Subject: A/C MODE SELECTOR DIAL DOES NOT STAY IN "DEFROSTER VENTS" POSITION - (MANUAL A/C ONLY)	Bulletin No: 07-001/14
	Last Issued: 07/08/2014

2013-2015 CX-5 vehicles equipped with manual type air conditioning system with VINs lower than JM3KE*****488298 (produced before June 1, 2014)

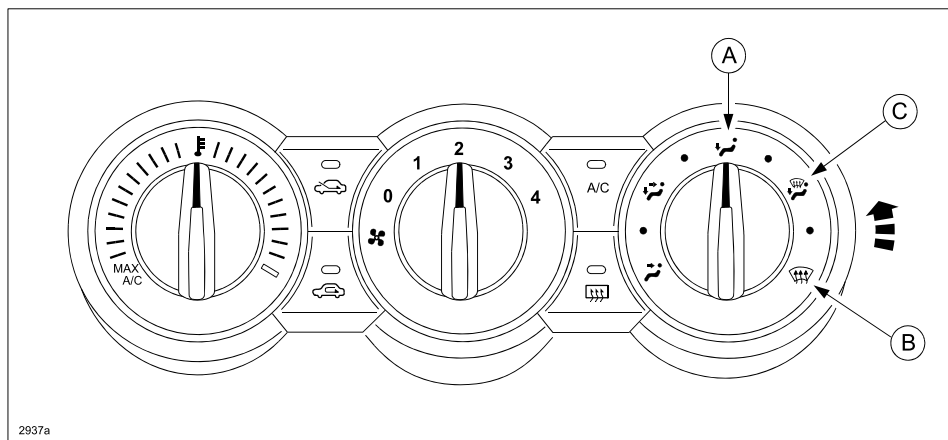
When selecting the "Defroster Vents" position (B) with the Mode Selector Dial (A), some customers may notice the dial does not stay in the "Defroster Vents" position and returns to the "Defroster/Floor Vents" position (C).

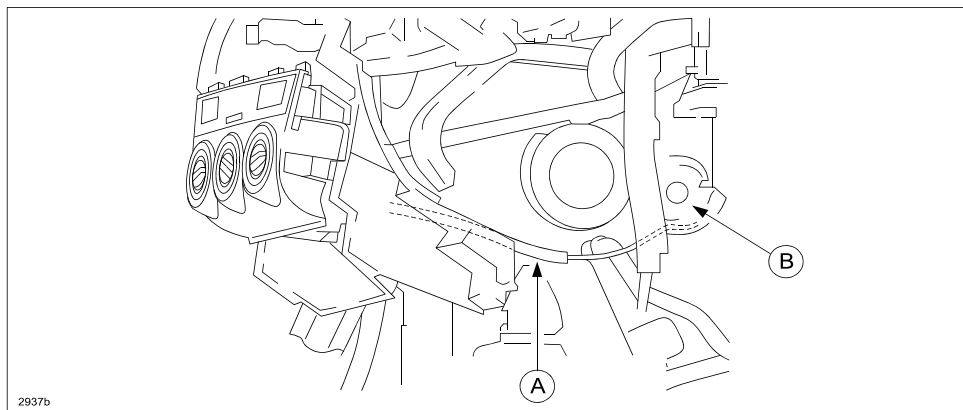
This concern may be due to a production variation. Some of the mode control wires (A) may be too long to transmit movement from the mode selector dial to the link (B). The length of the mode control wire has been shortened to eliminate this concern.

1. Replace the mode control wire with a modified one according to the instructions on MS3 online or the Workshop Manual (section 07-40 CLIMATE CONTROL UNIT REMOVAL/INSTALLATION [MANUAL AIR CONDITIONER])
2. Verify the repair.
